City of Duluth

City of Duluth Bid # 13-0426
Job Description: Cross City Trail
City Project No. 0568TR
S.P. 118-090-020 and 118-090-022

Addendum #1

CROSS CITY TRAIL - PHASE 1

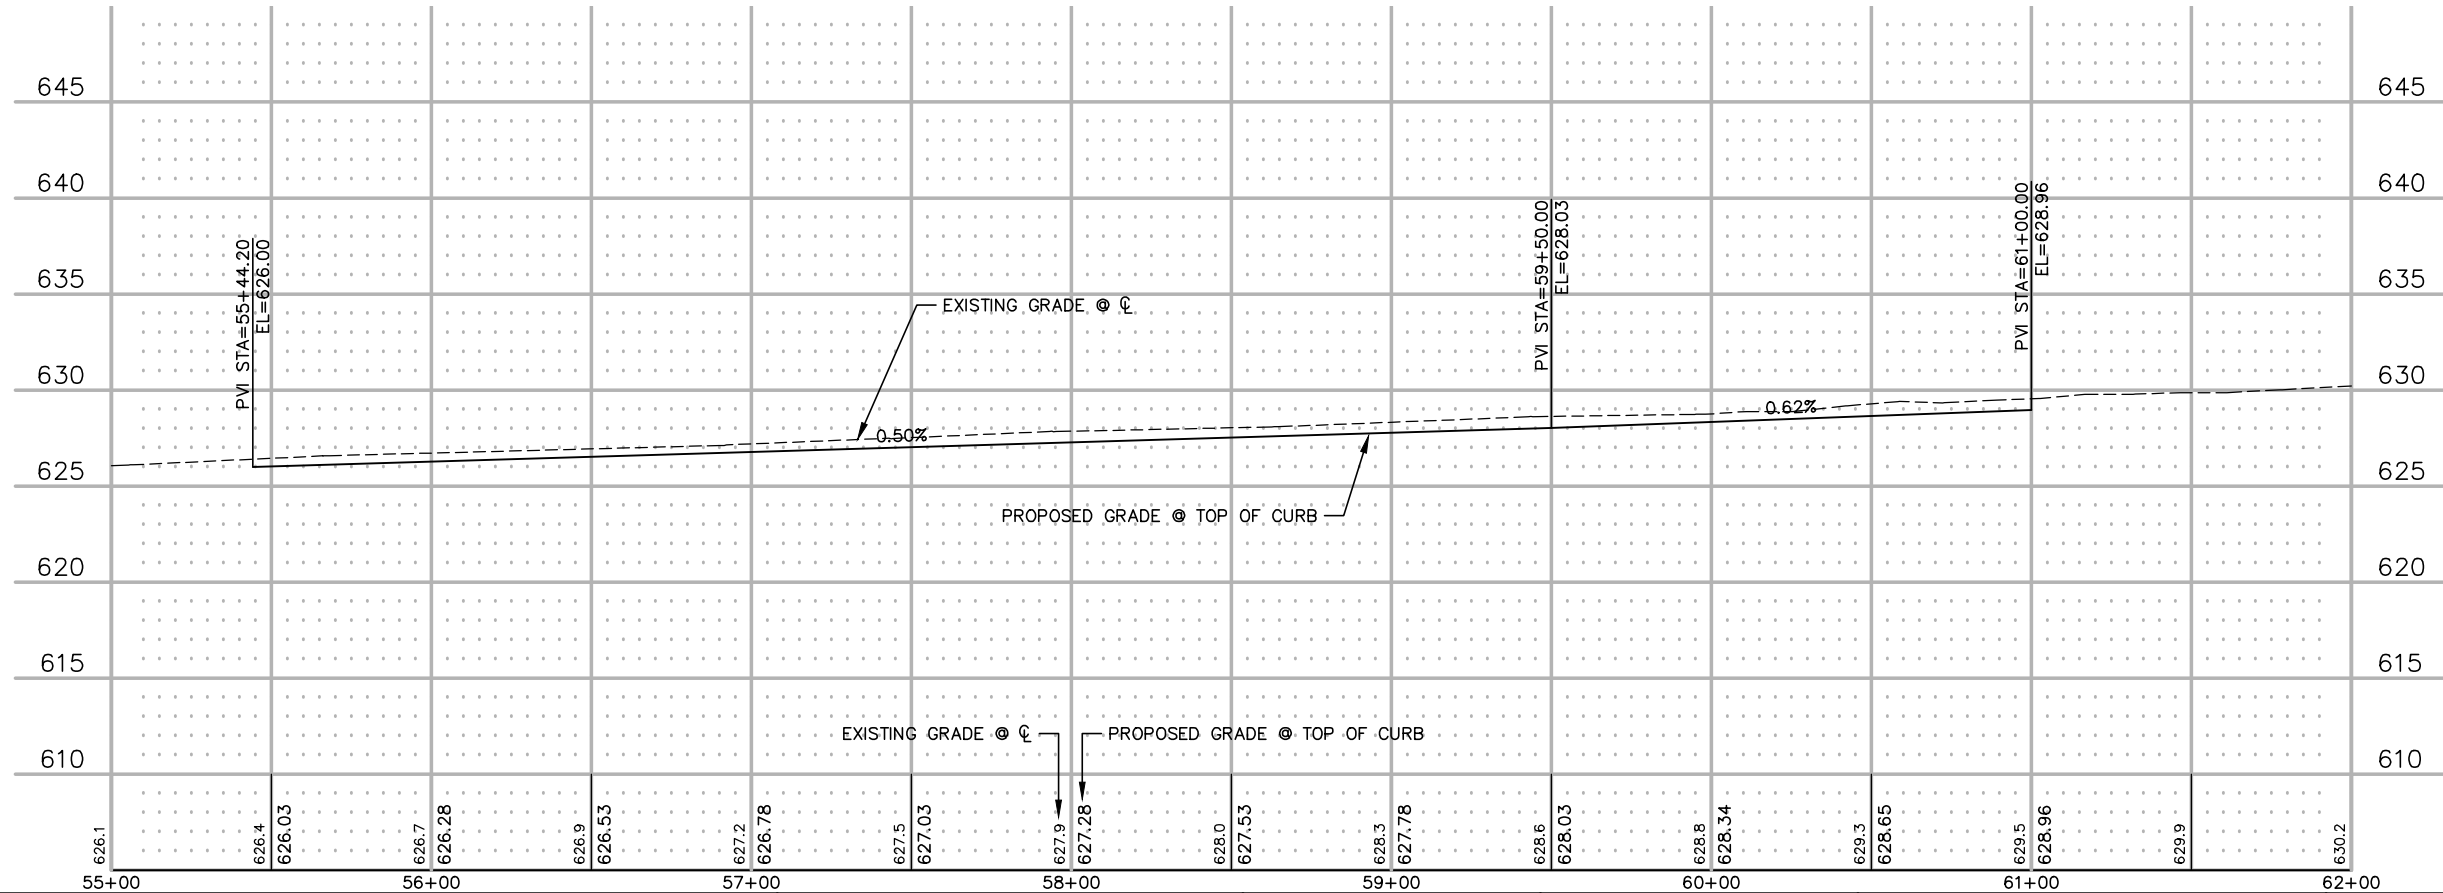
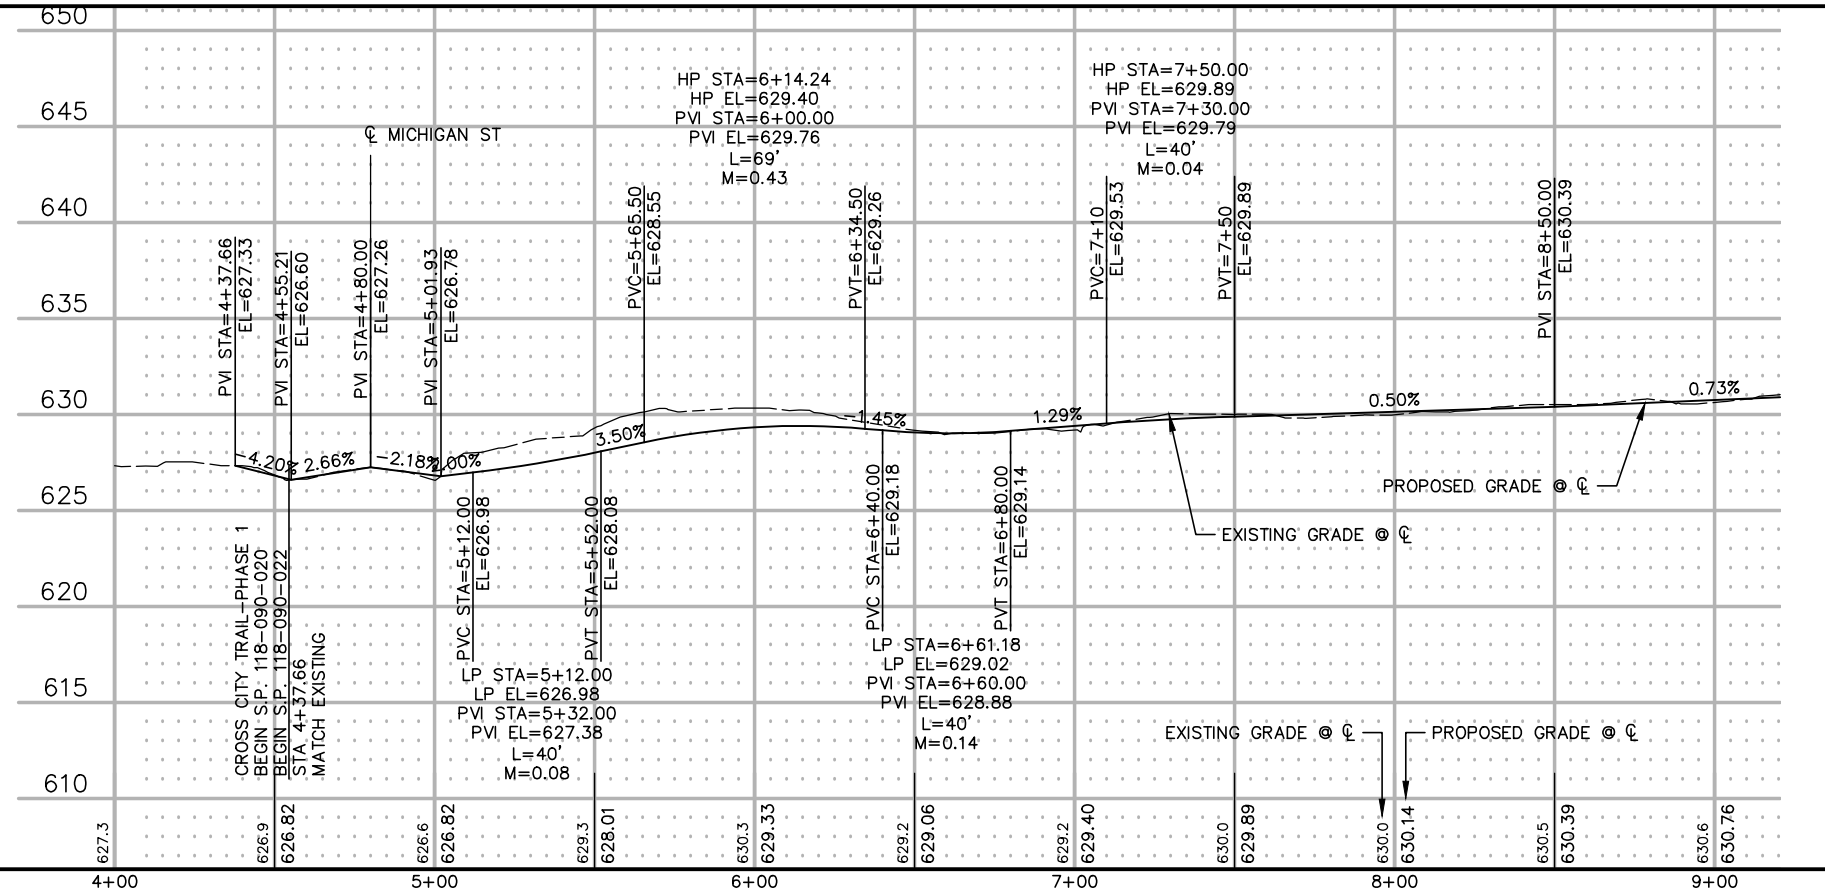
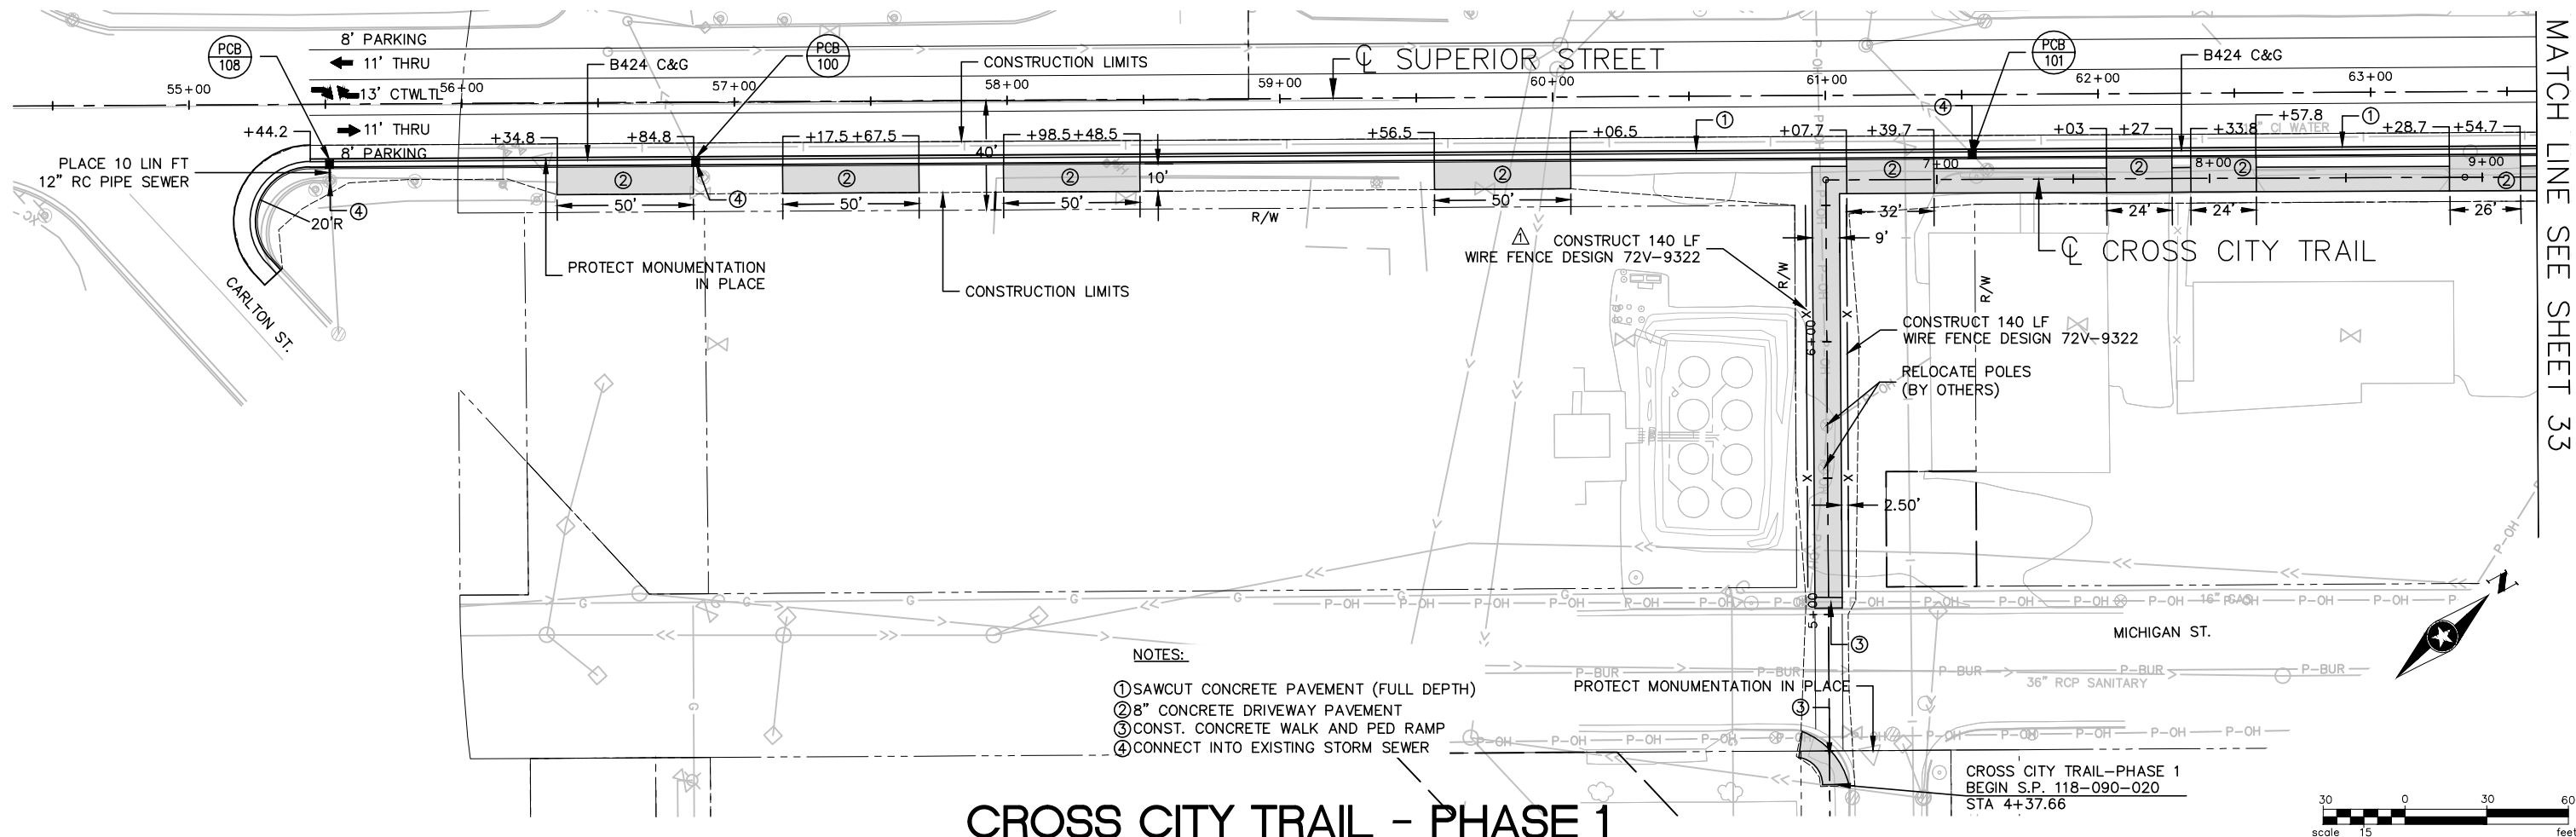
DRAWN BY: ACO	7/16/13	CHANGED TRAIL WIDTH FROM 10' TO 9'	I HEREBY CERTIFY THAT THIS PLAN WAS PREPARED BY ME OR UNDER MY DIRECT SUPERVISION AND THAT I AM A DULY LICENSED PROFESSIONAL ENGINEER UNDER THE LAWS OF THE STATE OF MINNESOTA. Matthew J. Bolf P.E. Date: 07/19/2013 Lic. No. 43913		CITY OF DULUTH CITY PROJECT NO. 0568TR S.P. 118-090-020 S.P. 118-090-022	PLAN AND PROFILE SUPERIOR STREET	FILE NO. DULUT 109680	31 115
DESIGNER: JCK		CHANGED SHOULDER WIDTH FROM 3' TO 4'						
CHECKED BY: MJB		ADDED WIRE FENCE DESIGN 72V-9322						
DESIGN TEAM	NO.	BY	DATE	REVISIONS

PLAN AND PROFILE

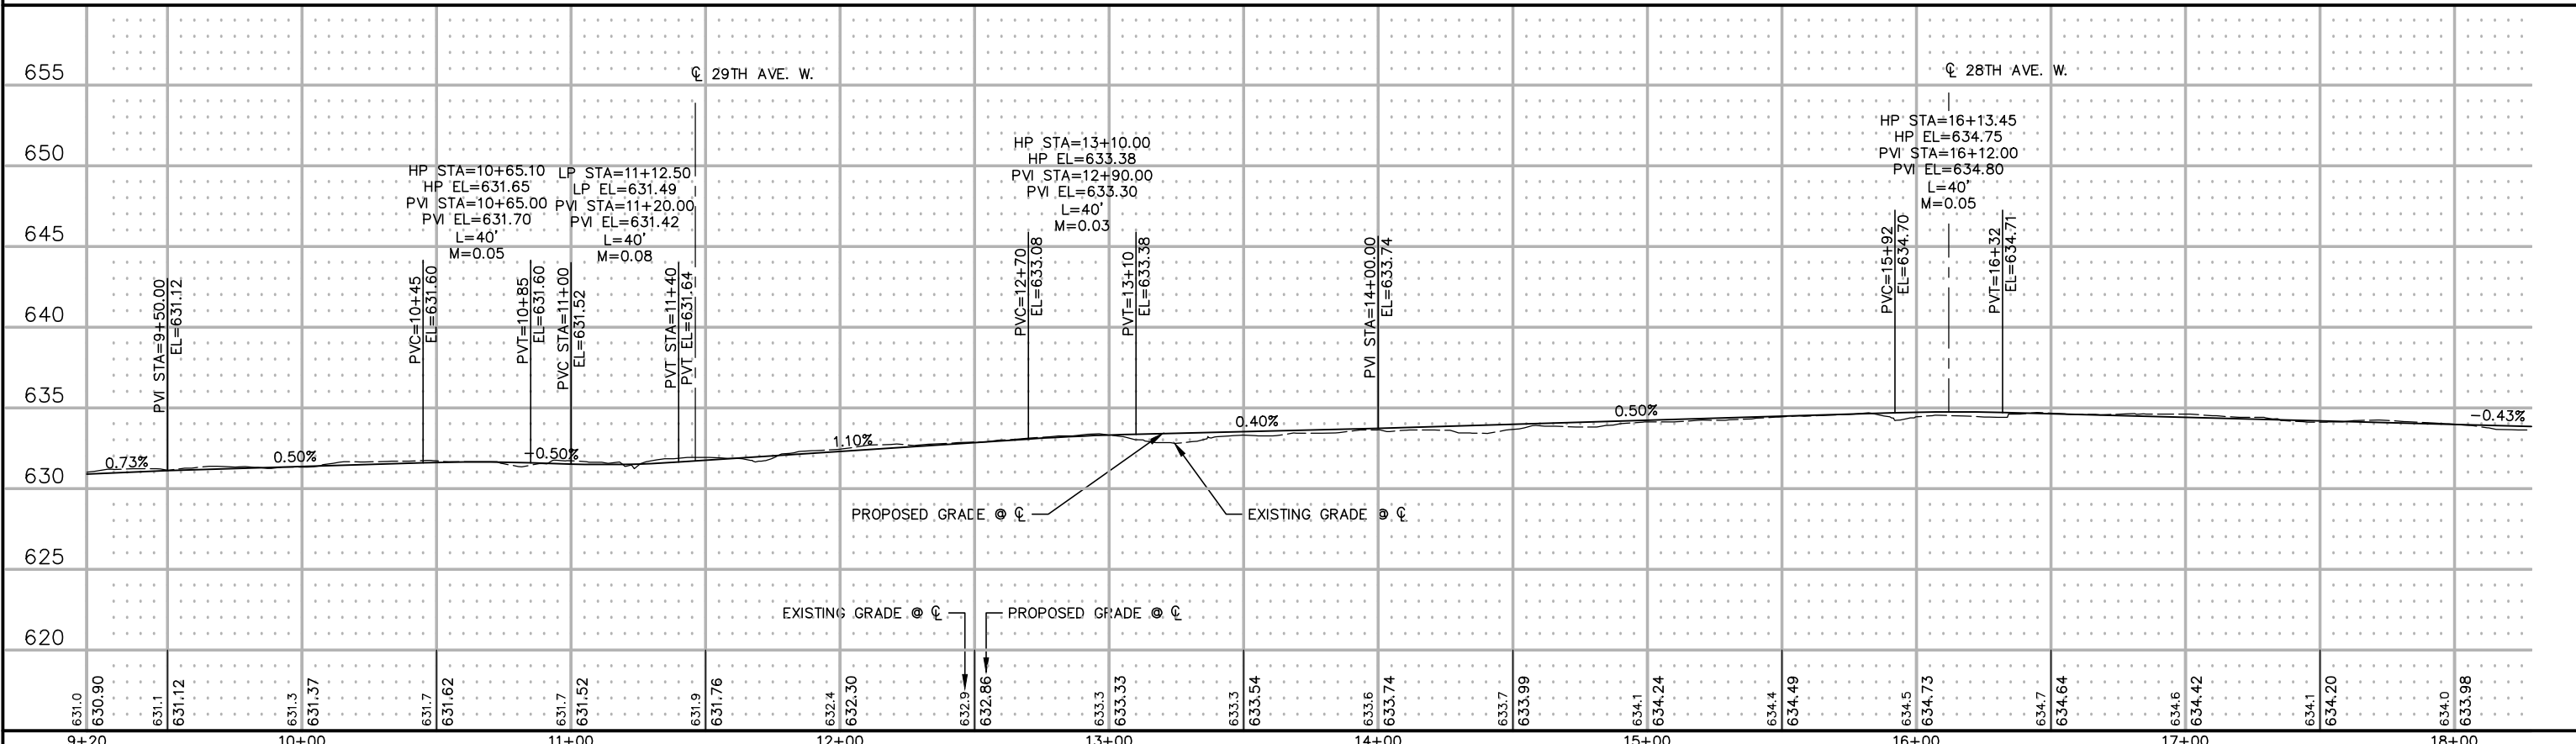
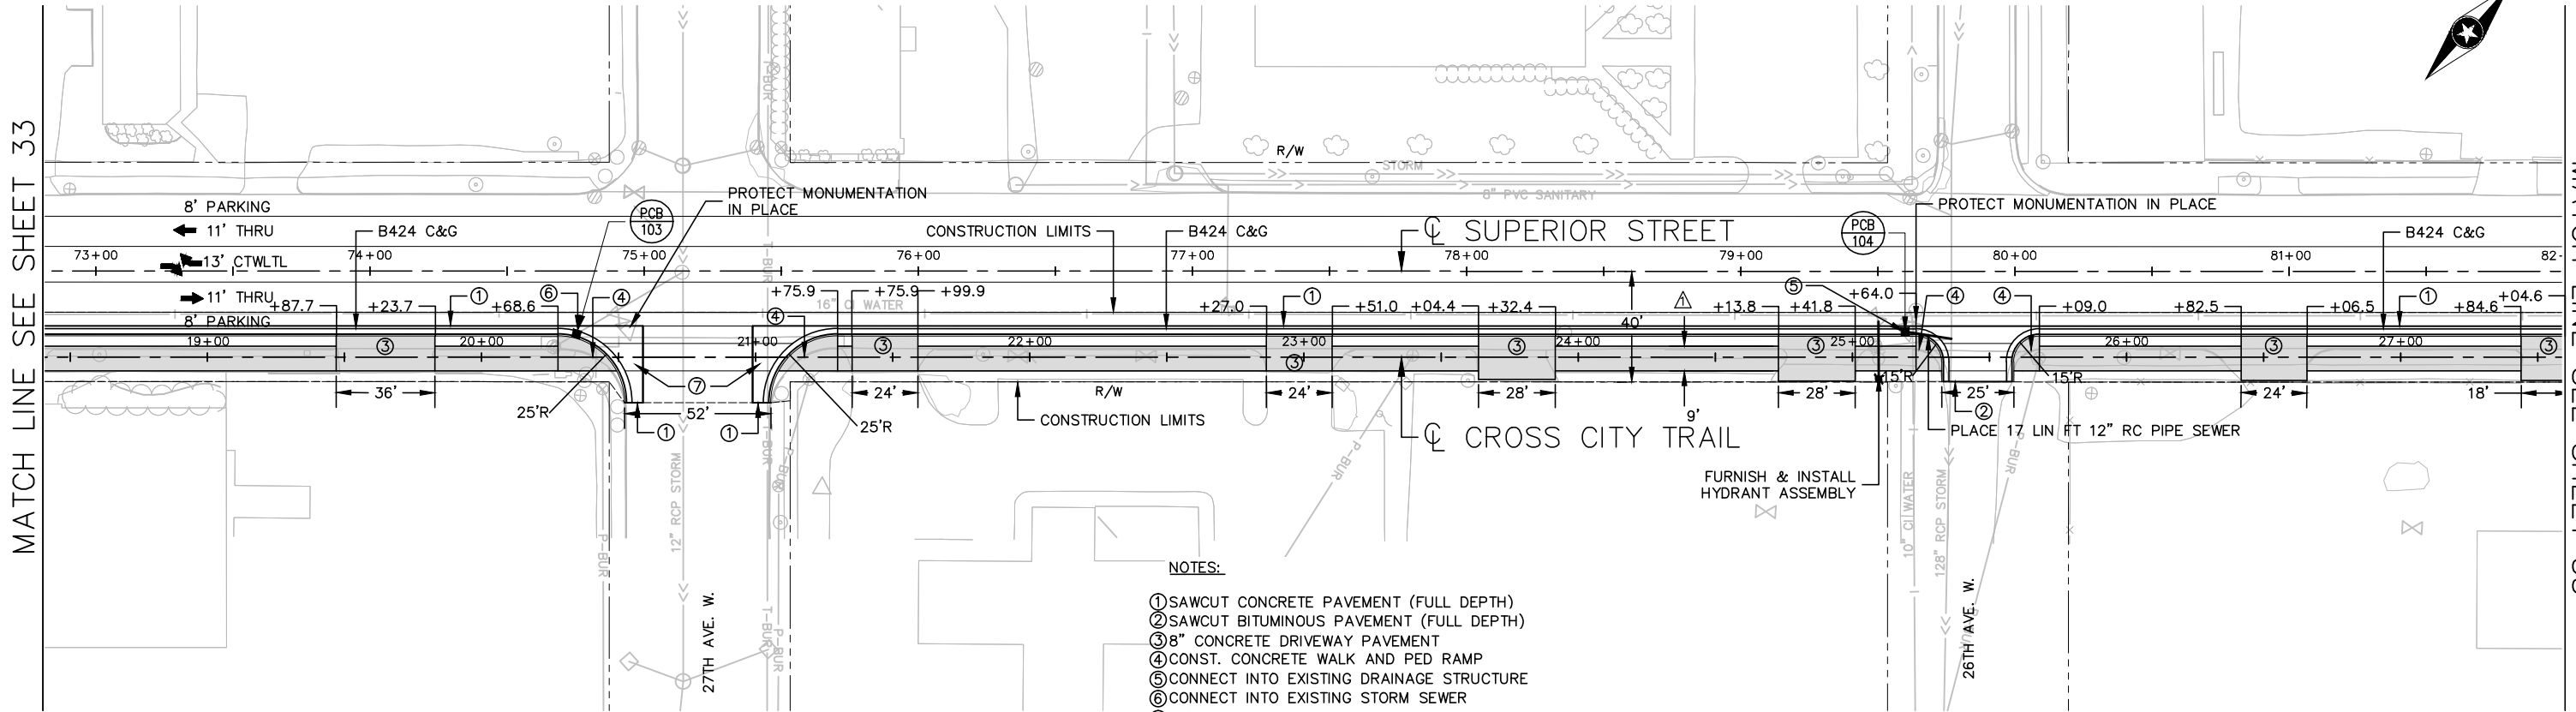
ACO	7/16/13	CHANGED TRAIL WIDTH FROM 10' TO 9'
		CHANGED SHOULDER WIDTH FROM 3' TO 4'
